CITY PLANNING COMMISSION

- A. Negative Declaration
- B. Variance to waive the City's standard surfacing requirement for a portion of the storage, service and sales area for a proposed construction equipment sales and service facility.
- C. Plan Review for a 35,282+ square foot construction equipment sales and service facility on 7.7+ acres in the M-1S-R zone.

LOCATION: Northwest corner of Bell Avenue and Beloit Drive

P88-440

EXHIBIT A SITE PLAN

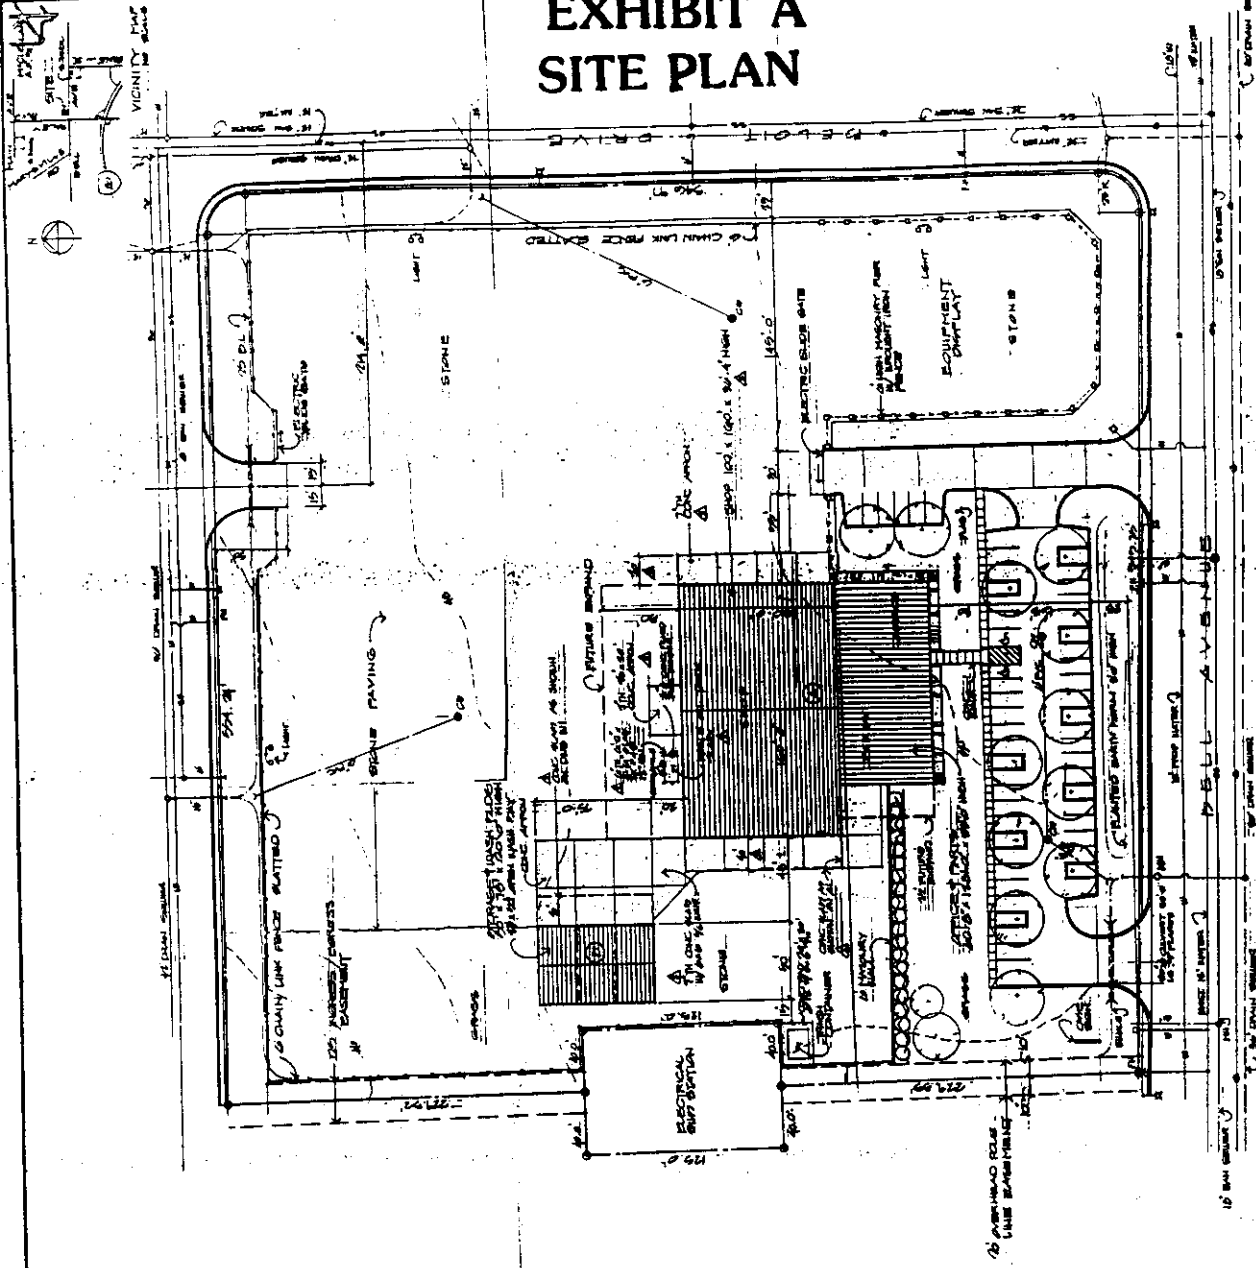
Forty eight (48) parking spaces are indicated on the submitted site plan. Staff has determined that there are three main components to the proposed case company operation, an office component (5,338 square feet); a commercial component (10,194 square feet); and a warehouse/industrial component (19,750 square feet). Using the parking ratios required for office, commercial and industrial uses Planning staff has determined that 53 parking spaces are required. The site plan will need to be revised to accommodate these five additional spaces. One loading/unloading space and bicycle spaces will also be required for the proposed use.

The applicant has indicated two signs to identify the Case facility: a 113+ square foot attached sign painted to the south side of the building and a 135+ square foot, 30+ foot high detached pole sign. Planning staff recommends that the pole sign be replaced with a detached monument sign. Staff finds that a monument sign would be more aesthetically pleasing and be compatible with the Sacramento Security Park complex on the south side of Bell Avenue which also prohibits pole signs.

4. The proposed chainlink fence located around the perimeter of the equipment storage area shall utilize vinyl slats as a screening device.
5. The submitted site plan shall be revised to indicate 53 vehicle parking spaces, one loading/unloading space and the location of the required bicycle spaces.

7. All detached signs located on the site shall be monument signs with a maximum height of eight feet. The design and materials of any proposed monument sign shall be subject to Planning staff review and approval prior to issuance of a sign permit.

EXHIBIT B STAFF EXHIBIT

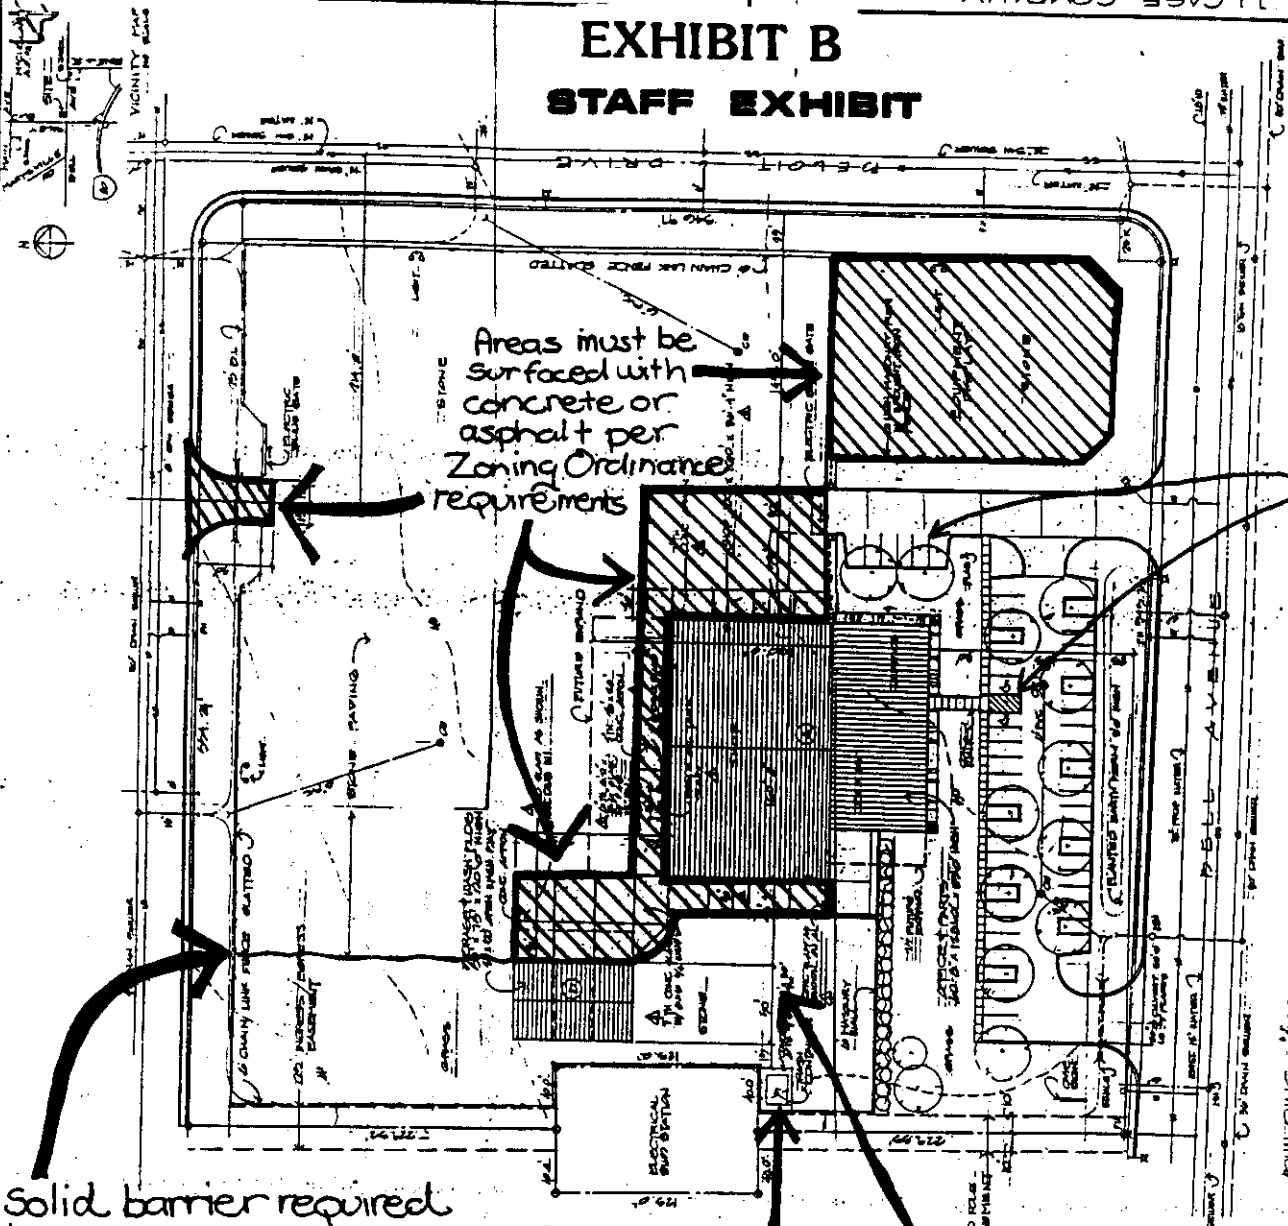
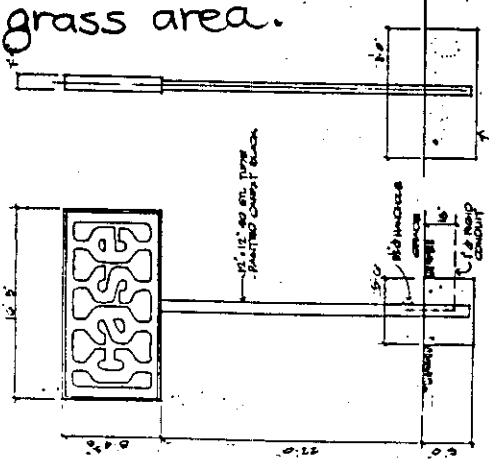
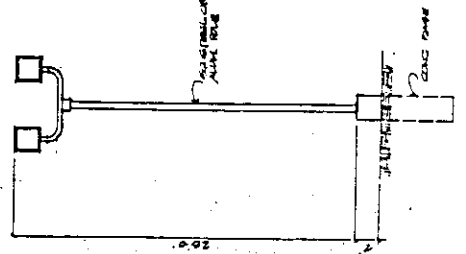
Parking lot
to meet
City
Surfacing
and shading
requirements

Solid barrier required
between stone and
grass area. Storage
not permitted in
grass area.

Trash enclosure
to meet Zoning
Ordinance
Surfacing
requirements

Area must meet
City surfacing
requirements if
used for vehicle
repair

6. All equipment repair areas, the parking lot on the southern portion of the site, all driveways, areas surrounding the two buildings located on the subject site and the equipment display area shall be surfaced in accordance with City standards (see Exhibit B). Equipment storage areas may be surfaced with rock or crushed stone. Any grass areas shall be barricaded from vehicle storage areas. Drainage for the vehicle storage areas must comply with the requirements of the City Public Works Department, the Fire Department and the City/County Health Department. The applicant shall revise the site plan to indicate those areas that will be surfaced in accordance with City requirements and those areas to be surfaced with rock or gravel subject to Planning staff review and approval prior to issuance of building permits.

EXHIBIT E ELEVATIONS

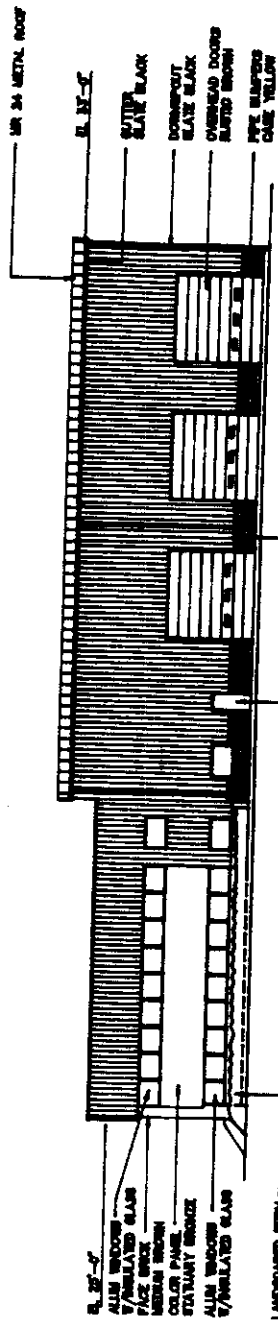
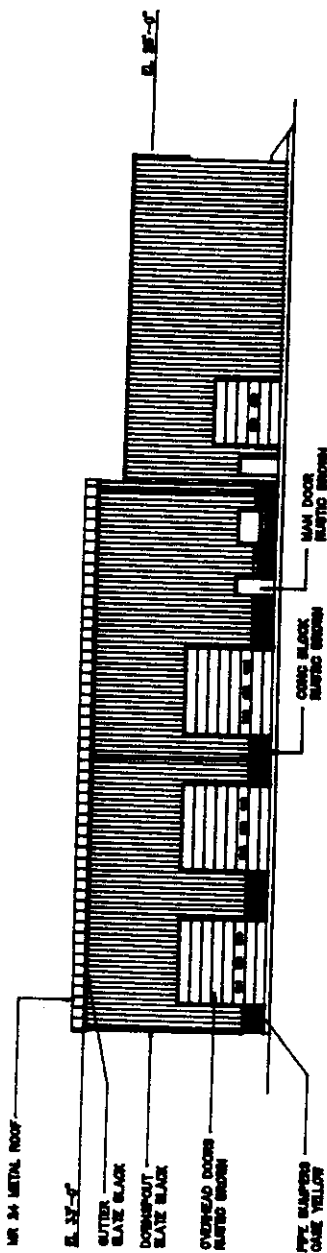
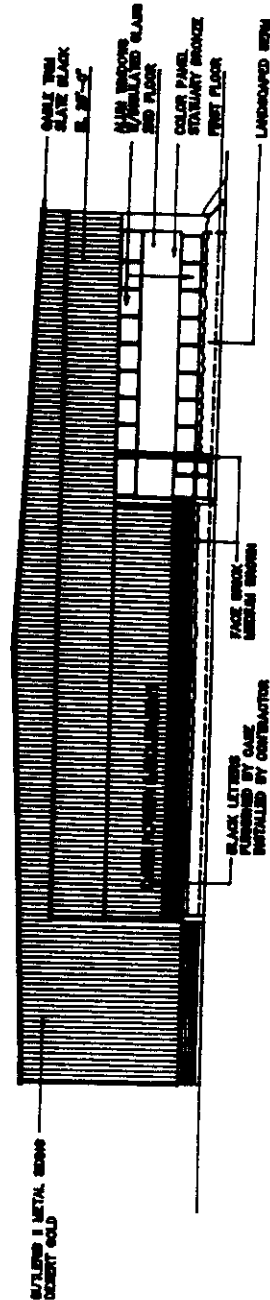
The applicant proposes that the two buildings on the site be constructed out of metal. Proposed colors are desert gold with brown and black trim. Planning staff finds that the front of the building which faces Bell Avenue should have some additional detailing to provide visual interest to this facade. This could be accomplished through the use of architectural projections or third dimensional design changes to the facade. Brick or tile could also be used as accent materials. Additional landscaping at the building entrance could also enhance the structure. Staff recommends that the applicant revise the south and east building elevations to include a decorative element(s) subject to Planning staff review and approval.

1. The applicant shall revise the submitted building elevations for the 31,532± square foot main building to add a decorative element to the south and east facades of the building. The revised elevations shall be subject to Planning staff review and approval prior to issuance of building permits;
